Technical Response to Groundwater Related Items Raised in “Draft ERD - Amendments Required - APP-0012119”

OUR REF	NS-16018-RP-WM-0005	DATE	9-Sep-24
TO	Vladimir Rios-vera	CC	Guy Stock
FROM	Michael Carroll

This memorandum has been developed to respond to specific feedback from EPA Services on the North Star Extension draft ERD (APP-0012119 – 23 August 2024). These items are listed below and addressed in turn within this document.

Figure 1: Predicted 2-D mounding associated with injection as a means of mitigating a source of drawdown

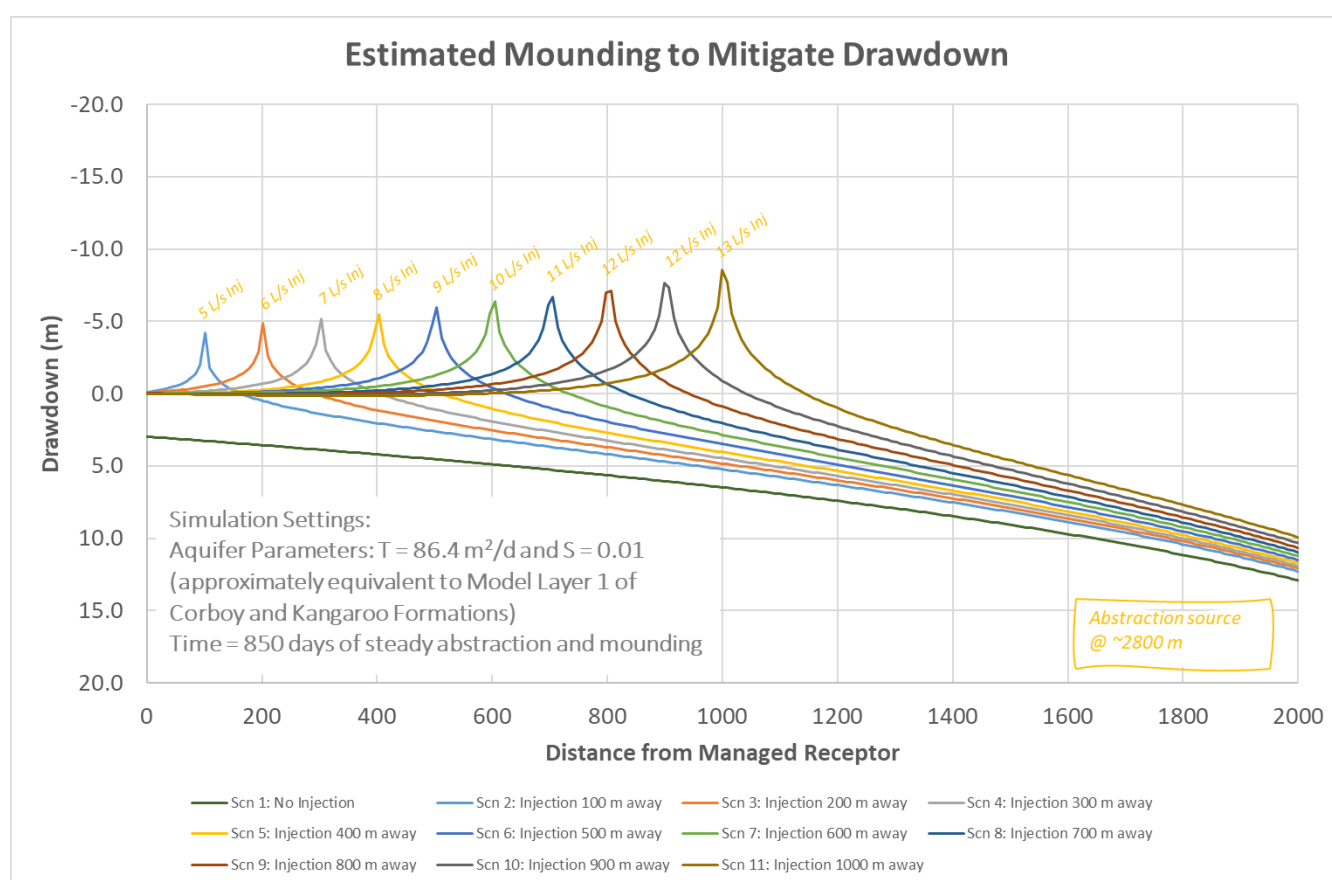
Section Reference	Comment	Action
1	Water reinjection is included as an option to manage groundwater levels (Appendix 36, Table 2 and Table 3).	<ul style="list-style-type: none"> a. Update the ERD to include an assessment of impacts to subterranean fauna as a result of groundwater reinjection. b. Provide maps of reinjection sites and modelled groundwater mounding in relation to restricted troglofauna species
3	The water balance in Table 5 (Section 2.1.10) currently accounts for 3.6 GL/a of TSF return water and 0.3 GL/a of dewatering and pit rainfall recovery. This is not aligned with the water sources in Section 2.1.9, which include 5 GL/a in-pit dewatering and 0.5 GL/a of TSF seepage recovery.	<ul style="list-style-type: none"> a. Update Table 5 to accurately represent water inflows and outflows.

An important consideration in the implementation of injection to manage groundwater levels is that the practice is not managed as a volume target (i.e. inject “x” GL/a) but rather as a means of creating a hydraulic barrier between the source of water level drawdown and the receptor. As shown in Figure 1 below, the barrier (injected water) results in flow towards the receptor as well as the source. The hydrogeological assessment (IB-5700-RP-WM-0002) and associated Groundwater Operating Strategy

A 2-D model has been developed to undertake a high-level assessment and support the suitability of injection as an adaptive management strategy as written in the Groundwater Operating Strategy. This model applies an arbitrary abstraction stress (to represent borefield or pit dewatering drawdown) which results in 3 m of drawdown at a hypothetical trigger bore. The 3 m drawdown can be considered representative of the magnitude of drawdown at stygofauna trigger bores which may prompt implementation of supplementation. Smaller values of drawdown would apply to pools; rendering the approach taken conservative. Ten (10) scenarios with injection at distances between 100 m and 1,000 m away from the trigger bore have been simulated. Figure 1 illustrates how the mounding remains largely localised to injection location, and that the magnitude of mounding increases as the distance from the trigger bore increases. The required injection volumes also increase with proximity to the source of drawdown. It is important to note that this outcome is specific to the applied hydraulic parameters; however the chosen parameters reflect a reasonable approximation of the weathered aquifer properties at Iron Bridge.

The outcome of this modelling assessment suggests that mounding is generally localised to the site of injection and can be managed if the objective is only to maintain water level at a receptor, rather than to discharge of excess volumes of water. A range of mounding radii of between 84 and 285 m is observed from the modelling outcome.
